STS-102/ET-107 Flight Readiness Review

External Tank Project

Design Change Resize Foam Thickness on LO2 Tank Ogive

Reworked (sanded) area at Station 536

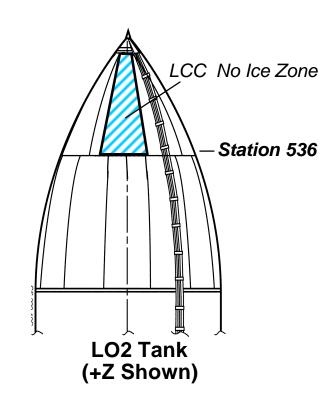
- Resized foam thickness on LO2 tank ogive
 - Decreased minimum net sprayed foam thickness on the +Z LO2 tank

- Producibility
 - Eliminate TPS rework (sanding) effort associated with potential negative contour deviations on the +Z LO2 tank adjacent to the Station 536 O2 weld
 - Contour deviations could, if not addressed, cause TPS cracking during tanking resulting in scrub or TPS debris

LO2 Tank 	STS-98/ET-106	STS-102/ET-107	
Station 404	2.15 <u>+</u> 0.25	1.85 <u>+</u> 0.25	
to	↓	↓	
Station 540	2.15 <u>+</u> 0.25	1.00 <u>+</u> 0.15	
Station 570 - 848	1.00 <u>+</u> 0.15	0.88 <u>+</u> 0.13
